Product Change Notification

113246 - 00

Change Notification #: 113246 - 00
Change Title: Intel® Server System R1208GL4DS
PCN113246-00, Product Design
Update System Rear Panel
Date of Publication: September 18, 2014

Figure One

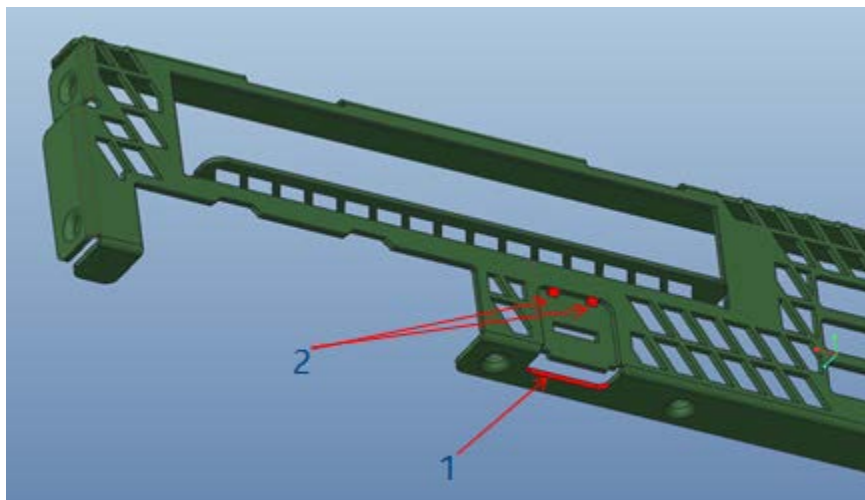
1. Add a connection at the bottom of the RMM4 (Remote Management Module 4) slot to improve structure strength. See item 1 in the Figure One.
2. Update the one big center joint to two smaller joints so that the joints will not conflict with the LAN cable connector latch. See item 2 in the Figure One.

Figure Three

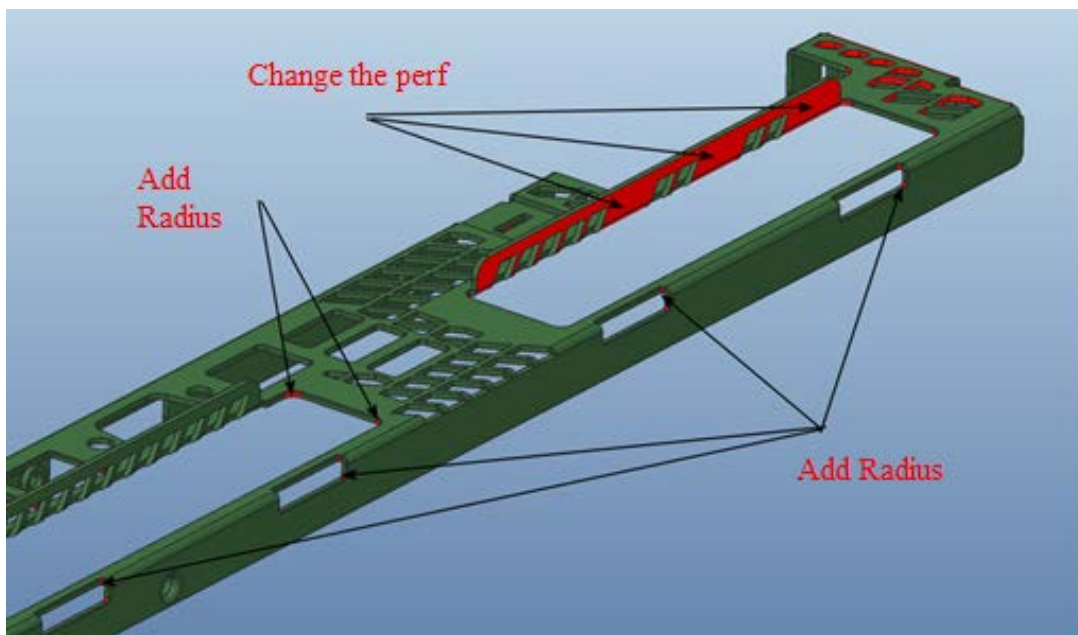
4. Update the perf and add radius to improve structure strength. See the Figure Three and Four.

Figure Five

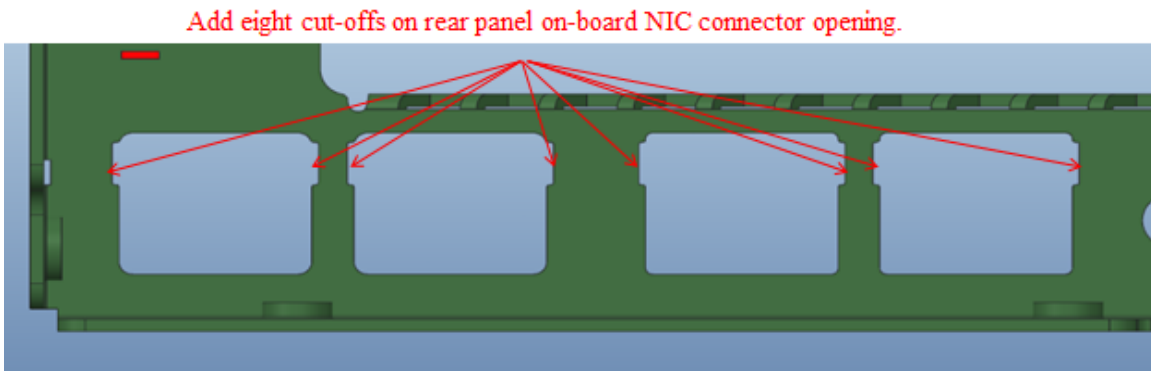
5. Add eight cut-offs around the on-board NIC (Network Interface Controller) openings to improve the LED visibility. See Figure Five.
